Capital Project No. WP-169
Long Term Control Plan II

Combined Sewer Overflow Long Term Control Plan For Newtown Creek

Appendix D: Supplemental Documentation July 2018

Revised October 10, 2018

Figure 2-8. Annual Rainfall Data and Selection of the Typical Year

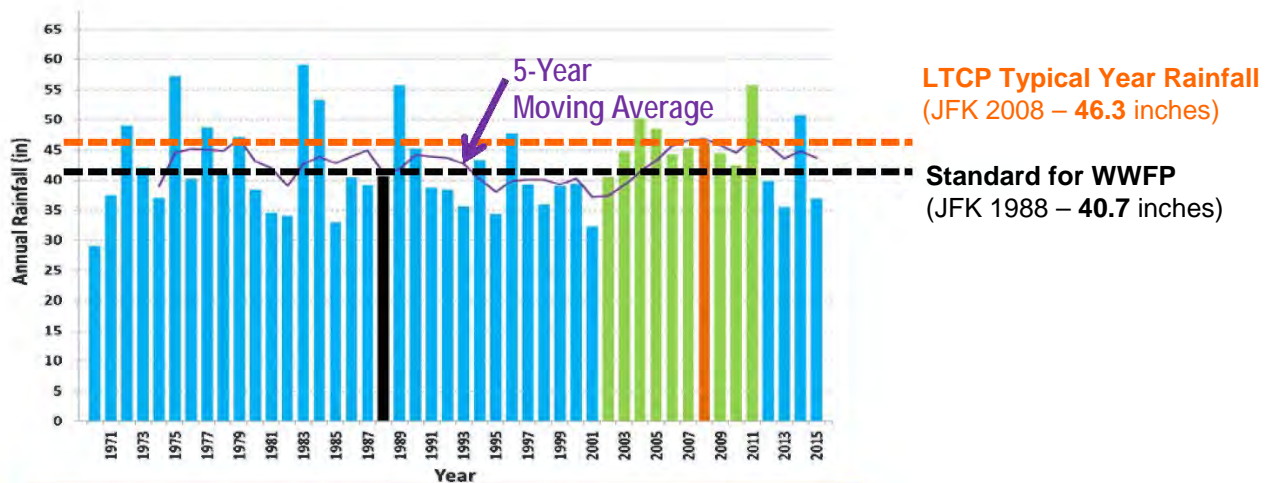
Figure 2-8 is deleted, and replaced in its entirety by the following Figure 2-8.
